Amendments to the Drawings:

REMARKS

FIG. 6

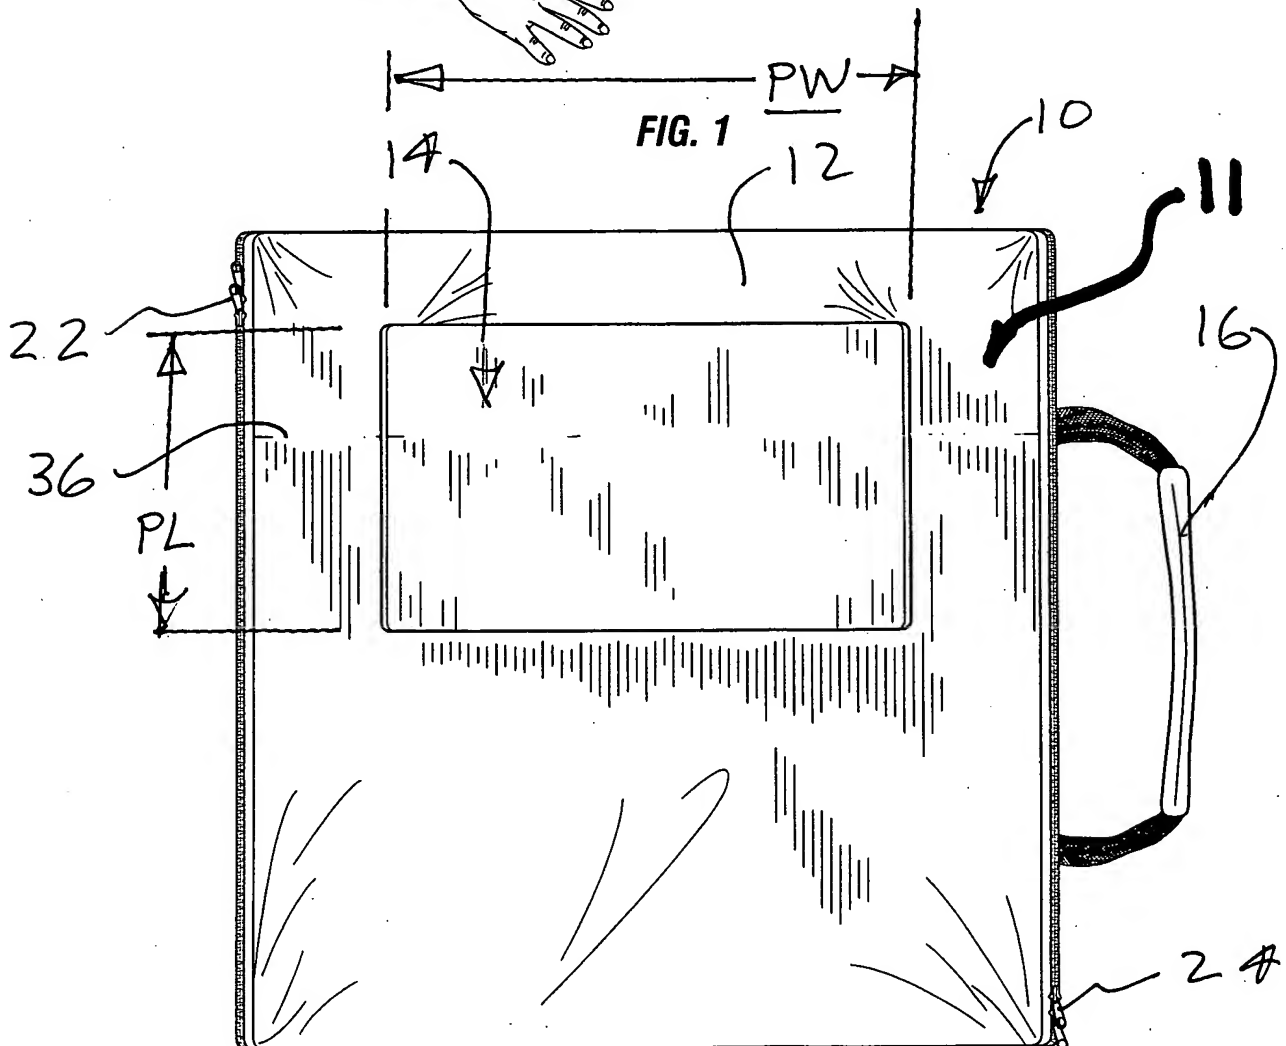
The attached sheet of drawings includes changes to Fig. 6. In Fig. 6, the previously omitted element number 11 has been added, along with a lead line.
